UNITED STATES PATENT AND TRADEMARK OFFICE

APPLICATION NO.	FILING DATE	FIRST NAMED INVENTOR	ATTORNEY DOCKET NO.	CONFIRMATION NO.
10/759,013	01/20/2004	Kiyoyuki Narimatsu	118380	6832
25944	7590	03/21/2006	EXAMINER	
OLIFF & BERRIDGE, PLC P.O. BOX 19928 ALEXANDRIA, VA 22320			TOTH, KAREN E	
			ART UNIT	PAPER NUMBER
			3736

Office Action Summary

Figure 1.
Figure 1 of Narimatsu Application No.
10/759013, showing "handle portion" 12.

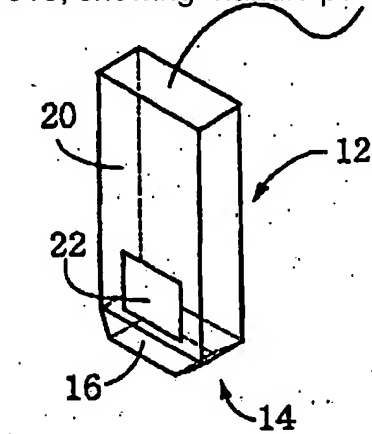
Regarding Claim 3, Archibald'022 in view of Asmar'107 teaches all the elements of the current invention except for the probe comprising a handle portion that is integral to the sensor portion and designed to be held by an operator.

Archibald'022 further teaches that said pressure sensor is contained within a main housing (element 140) that is designed to be held by the user when in use (column 3, lines 12-14). See figures 1 and 2 below.
